Office Action Summary

10/817,125

MUHANNA ET AL.

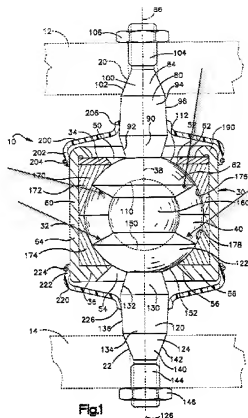
Tatar discloses the claimed invention except for wherein the second end of the rod has a partial hemispherical ball member having a convex inner surface facing an inboard side, and a conical surface facing an inboard side, a centrally located protrusion that is spherical, and wherein the conical surface tapers towards the spherical protrusion. El-Haw et al. disclose ball joint that is designed to allow two elongated members such as rods (for example, 94, 120, Fig. 2), articulate with respect to one another while remaining jointed. El-Haw disclose a partially hemispherical ball member (82) at an end of a rod-like member having a convex inner surface facing an inboard side (Fig. 2, 112), and an outboard side that has a conically tapering portion (see Fig. 1 below) and/towards a centrally located spherical protrusion.

It would have been obvious to one having ordinary skill in the art at the time the invention was made to construct the device of Tatar having at least a second end of a rod having a partial hemispherical ball member having a convex inner surface facing an inboard side, and a conical surface facing an inboard side, a centrally located protrusion that is spherical, and wherein the conical surface tapers towards the spherical protrusion as taught by El-Haw et al. to have improved flexibility within the assembly while maintaining a strong joint connection.
